PANAMA CANAL AUTHORITY	VARIATION	PAGE 1 OF 9
1. REQUEST FOR PROPOSAL No.: RFP-76161	2. CONTRACT No.: CMC-221427	3. DATE: September 24, 2013
		4. VARIATION No.: 076

Variation No. 076 is issued to incorporate the following changes:

Design and Construction of the Third Set of Locks

ATLANTIC LOCK COMPLEX	
MINDI CAMP	
RESTRICTED HANDOVER AREA	
DATE	10/10/2010
BY	SK-A-1016

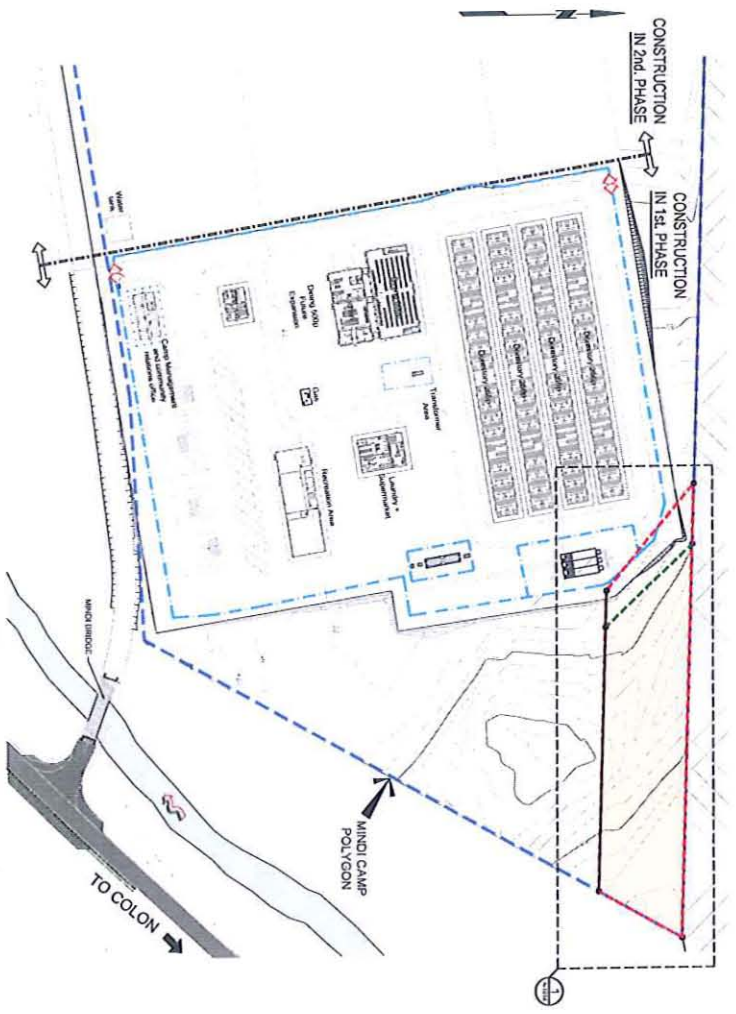
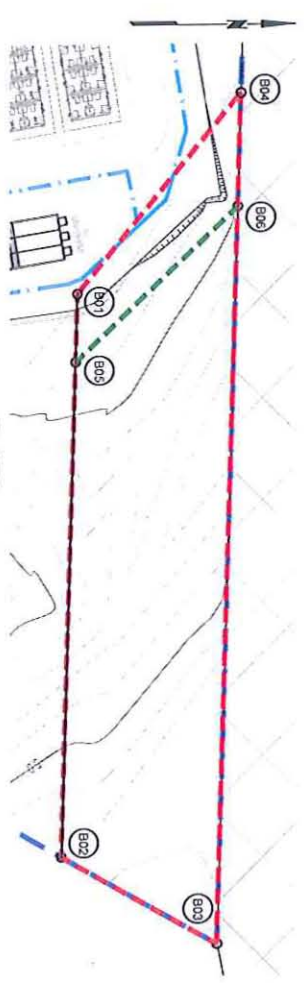
21. Mindi Campsite – Phase 2 - Retrieval of the area located within the Contractor's Polygon, as shown in the attached Drawing SK-A-A-1016, and as defined by the

following coordinates:

POINT	NORTHING	EASTING
B05	1028950.029	620415.187
B02	1028946.825	620524.149
B03	1028981.270	620543.540
B06	1028986.044	620381.190

The date established for the release and transfer of responsibility of the defined area is August 12, 2013.
